Design Review Board

DRB23-00745

Central Mesa Reuse Pipeline

Central Mesa Reuse Pipeline-Plants

Alternative Landscape Plan

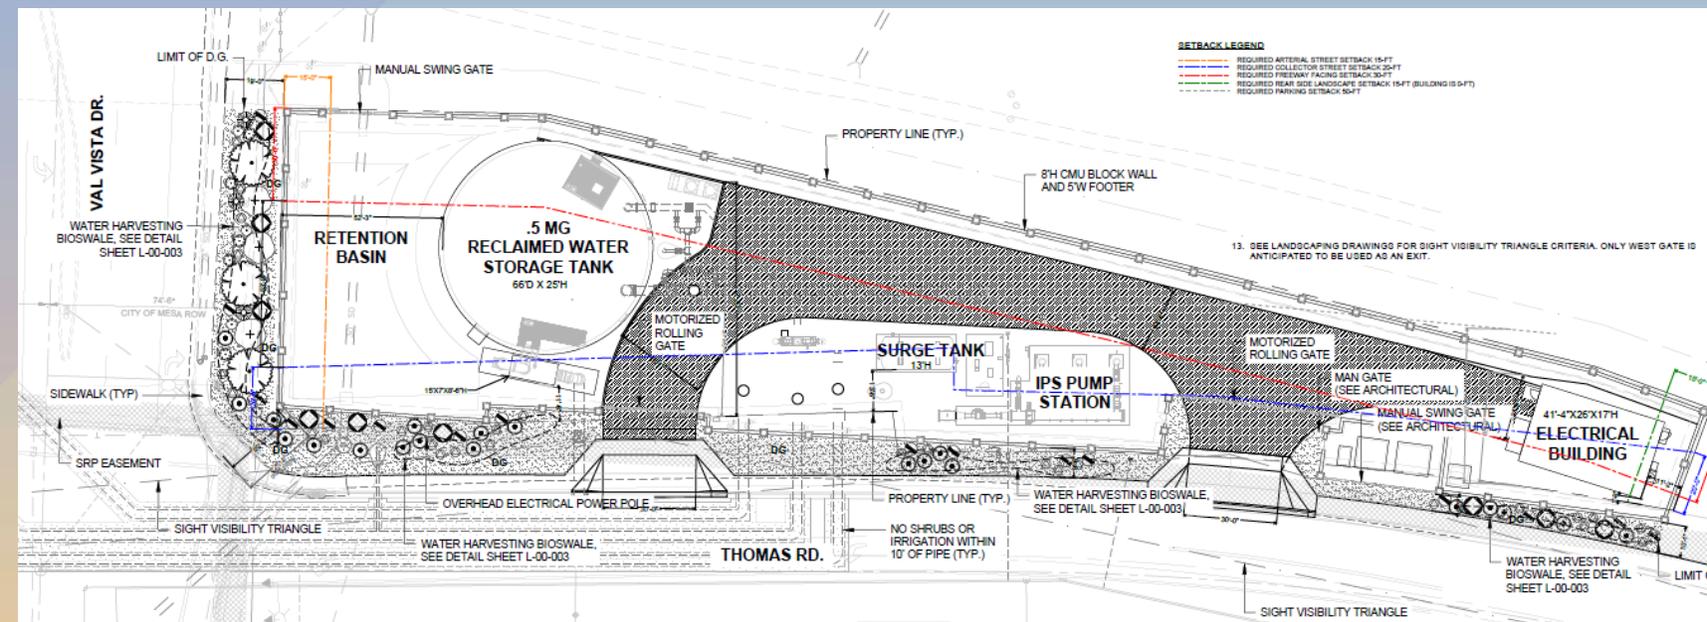
Concerns with lack of landscaping and trees on the site

- *Renderings were updated to better reflect the provided trees and shrubs on the site*

Tank Elevations

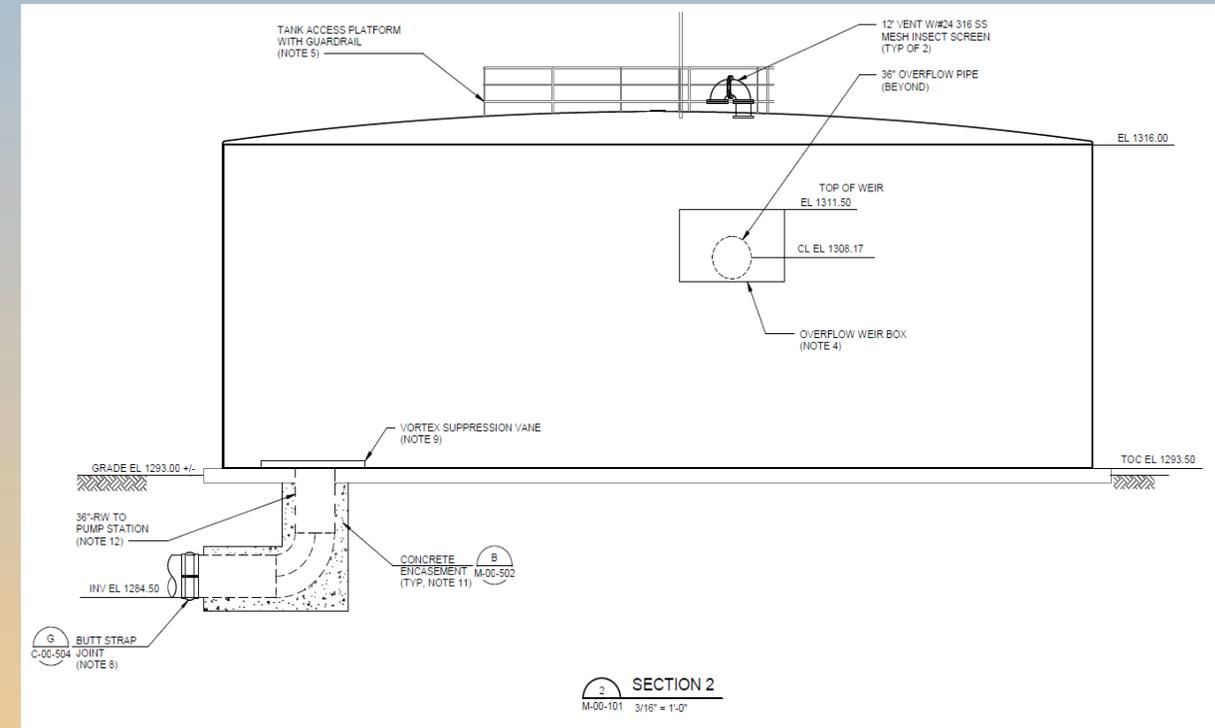
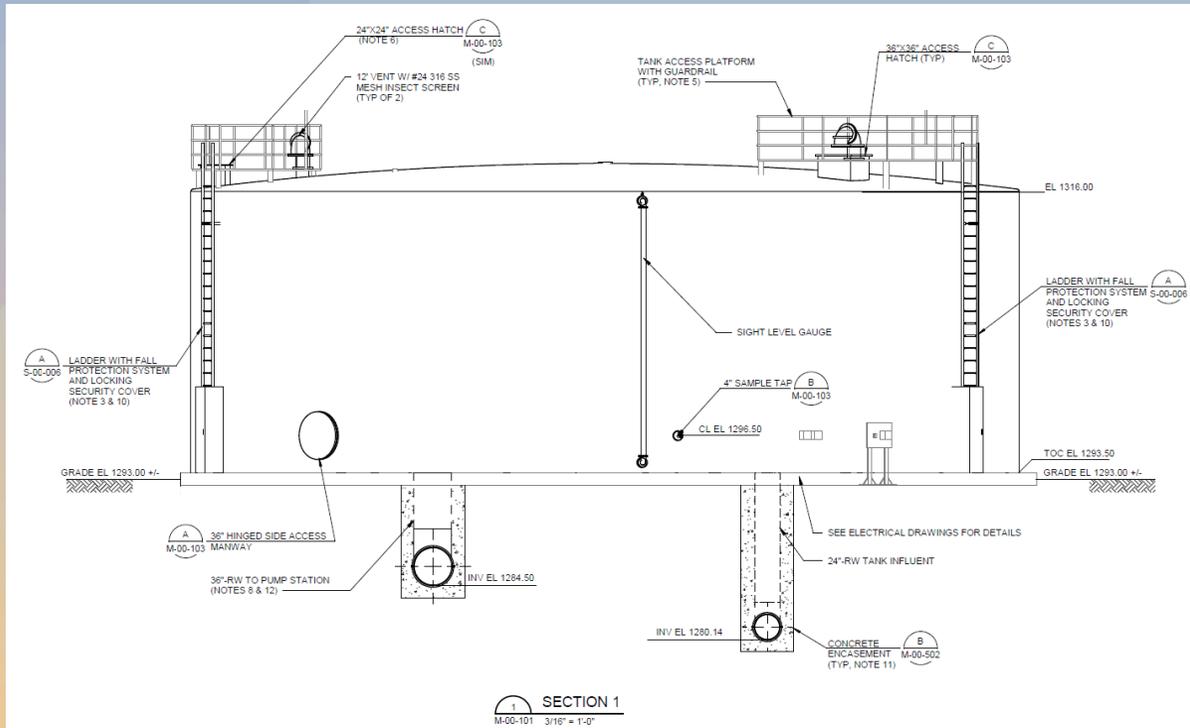
Requests lowering of the water tank height to the wall height

Requests a mural or mesa logo on the water tank

Move overflow piping on the south side of the tank to a different side

- *Reduction of tank height is not able to be completed due to project requirements*

- *Artwork will be added to the site. The City will work with an artist to finalize the design and a condition of approval has been added to the case to reflect this.*

- *To maintain proper operation of the site and minimize additional impacts, the overflow pipe should remain on the south side of the tank*

Perimeter Wall Elevations

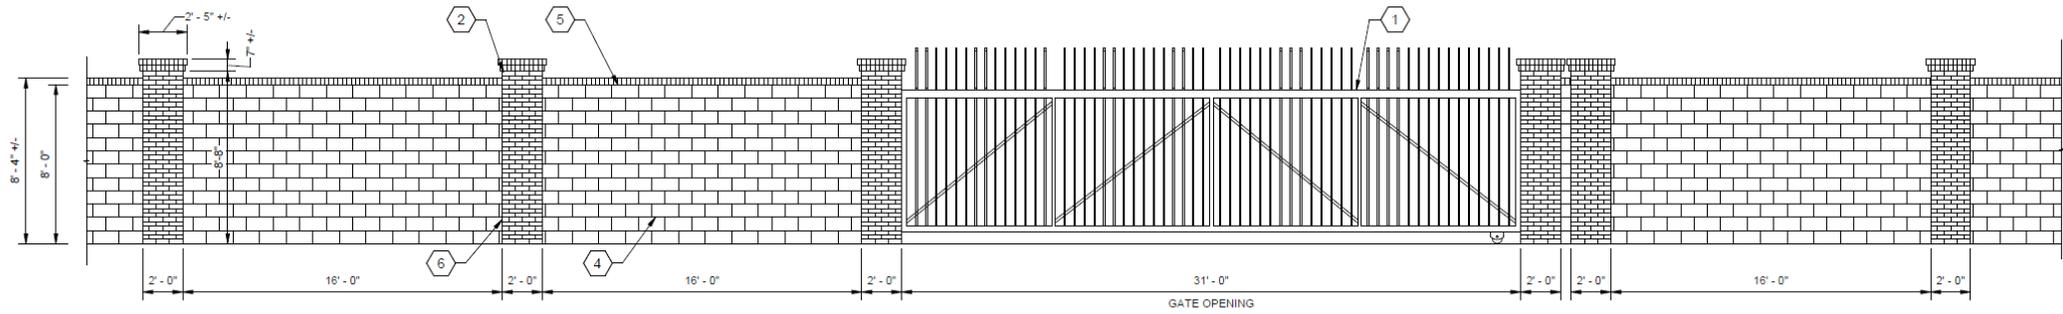
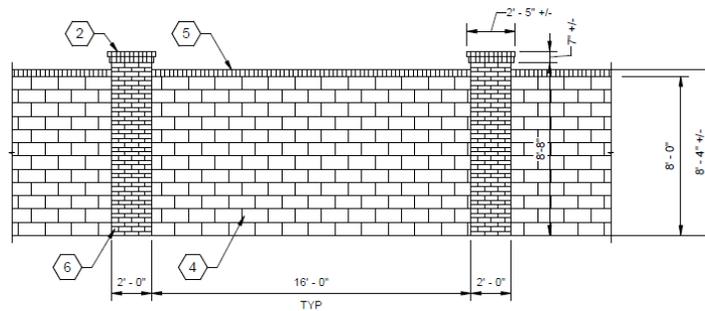
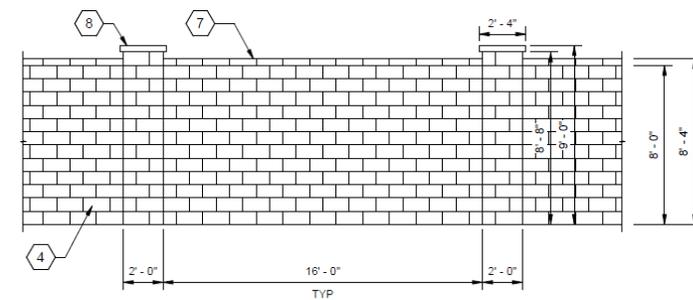
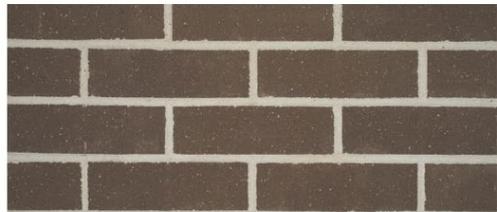
Wall design needs to be improved, recommend to move away from matching neighborhood wall and move to a green color

- *The wall and building were returned to the original darker block (willow green) and brick (graphite) color while maintaining the design to be cohesive with the surrounding communities*
